### **RFB NO. 315011 - ADDENDUM NO. 1**

#### **CONSTRUCT C&D MATERIALS RECOVERY FACILITY**

##### **DANE COUNTY LANDFILL SITE #2**

**FOUNDATION PLAN**  
 SHEET NUMBER  
**S100**

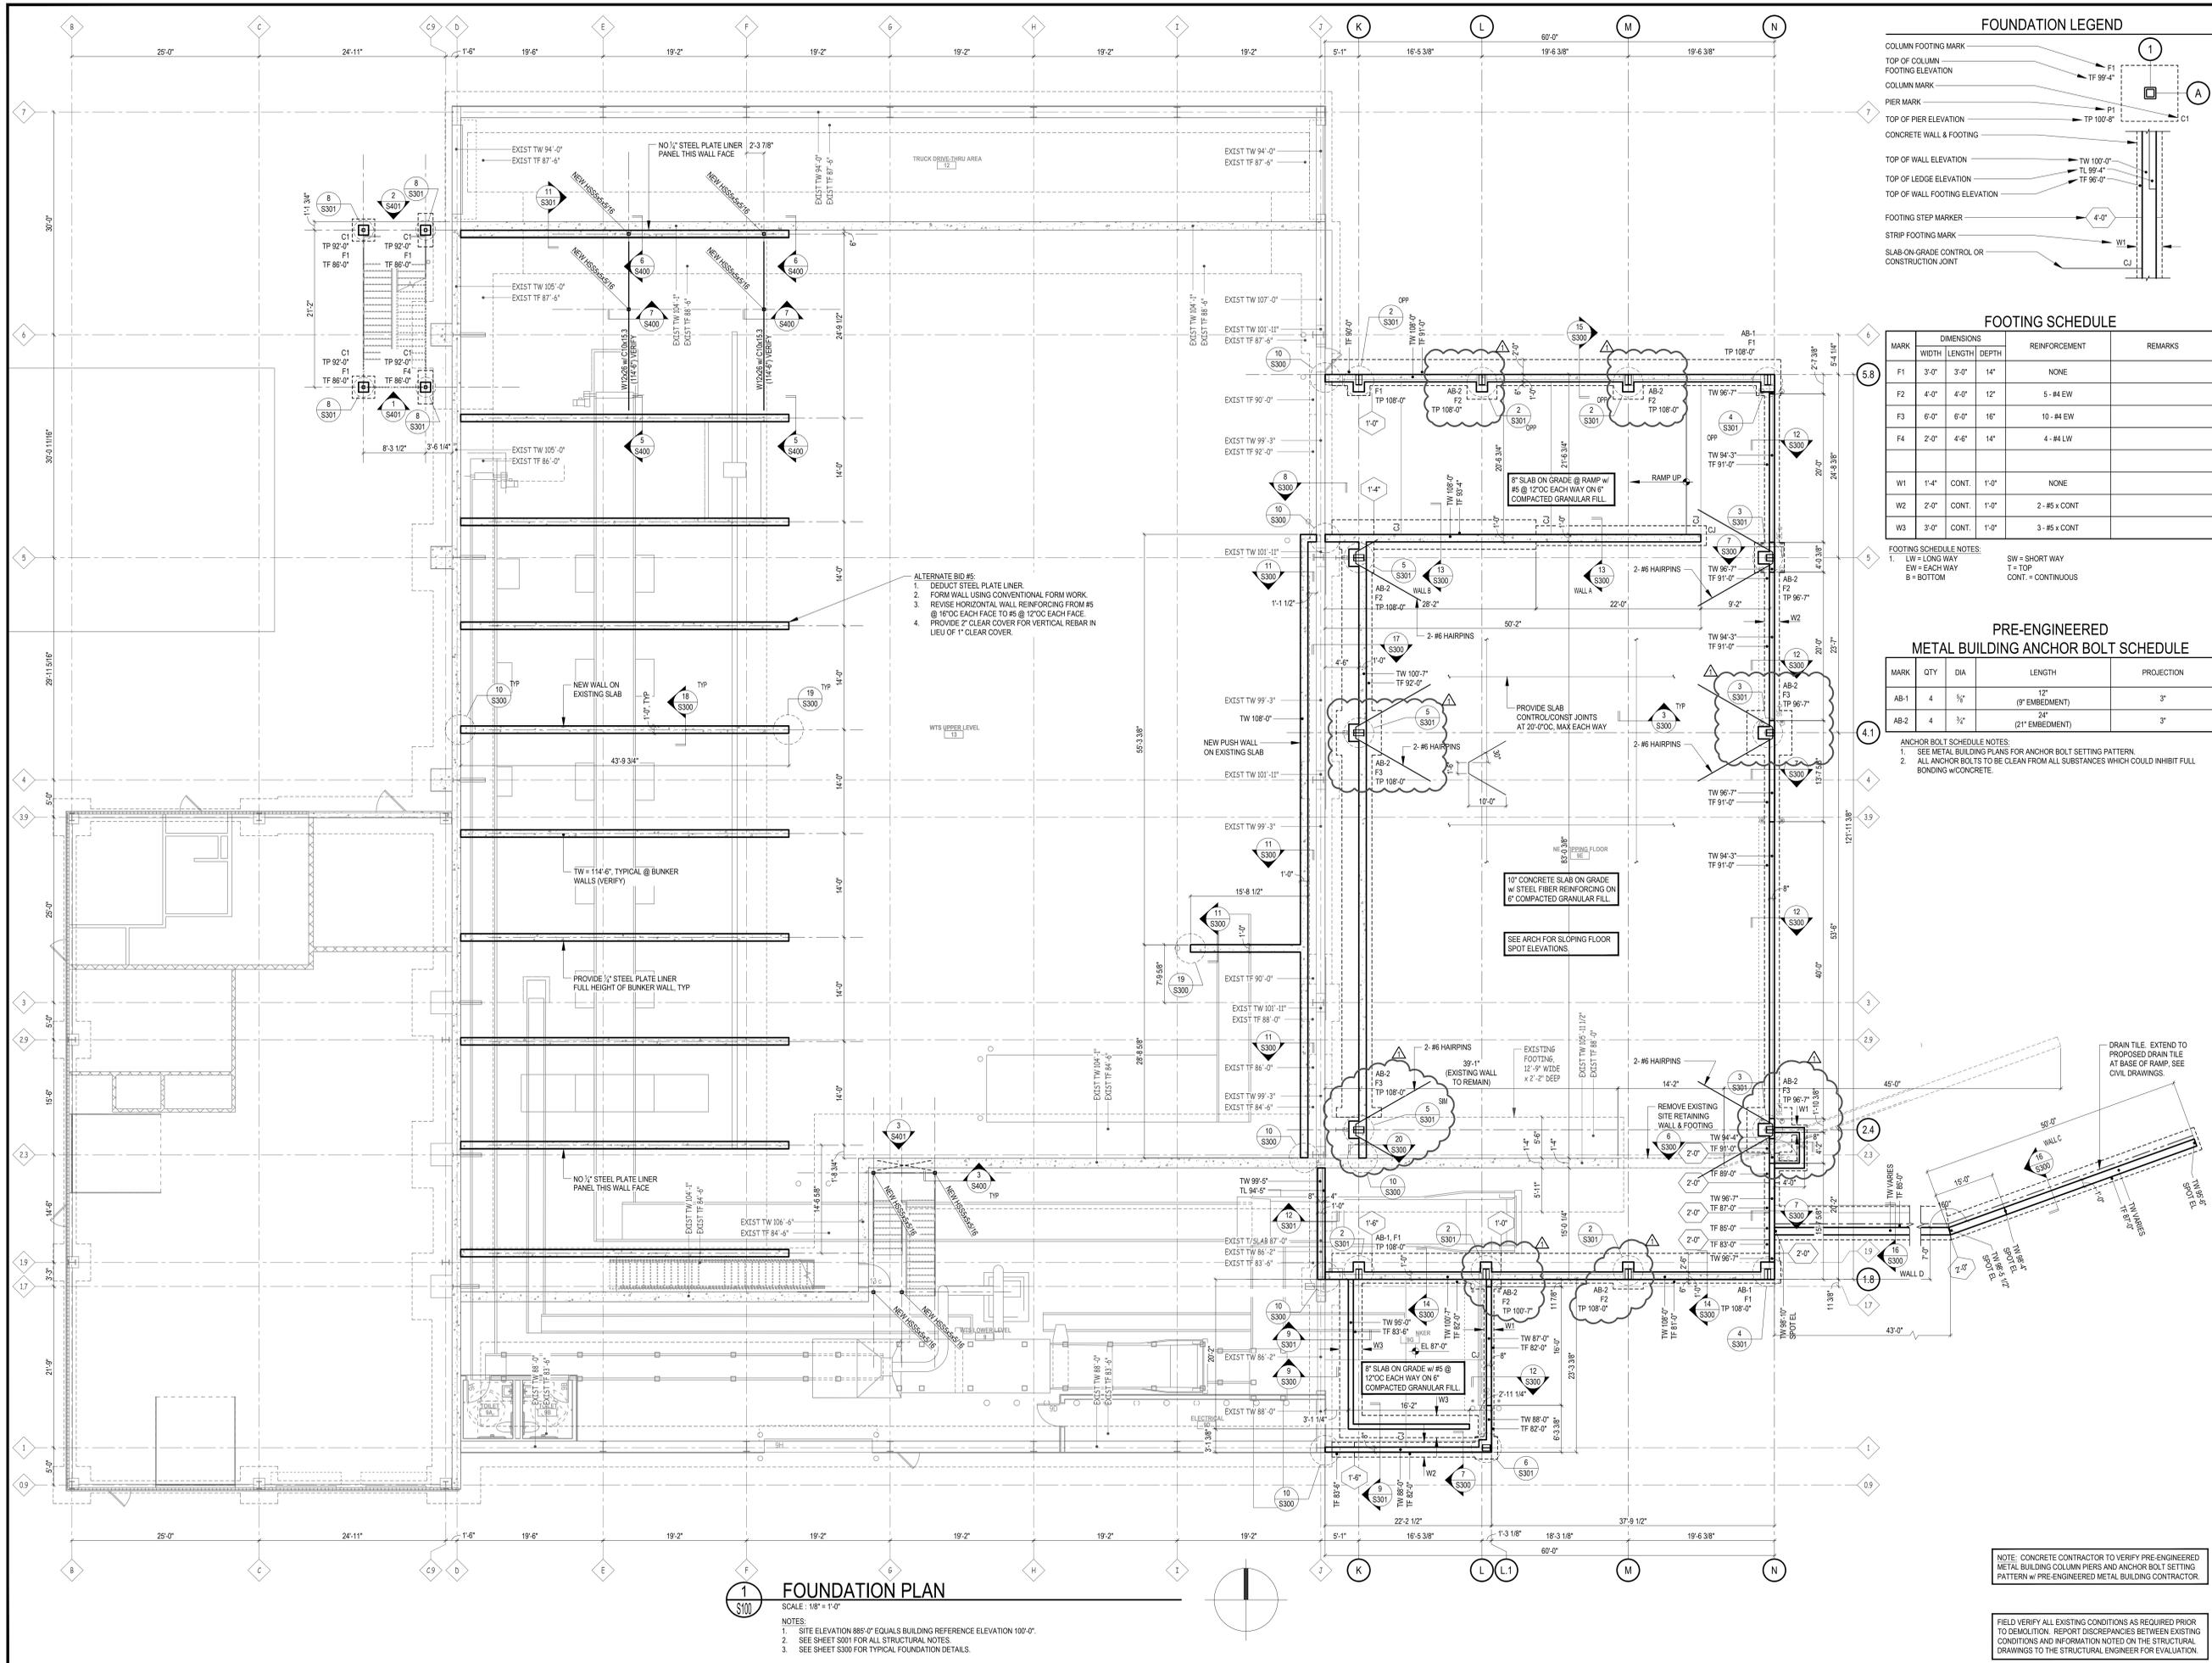
## **10. Sheets S100 – Foundation Plan**

Remove Sheet S100; replace with new Sheet S100, issued with this Addendum. The revised sheet is marked “Addendum #1”. The new sheet has been revised as follows:

Change the column footings located at L-5.8 and M-5.8 from F1 to F2

Change the column footings located at K-4.1, N-4.1, K-2.4, and N-2.4 from F2 to F3

Change the column footings located at L-1.8 and M-1.8 from F1 to F2
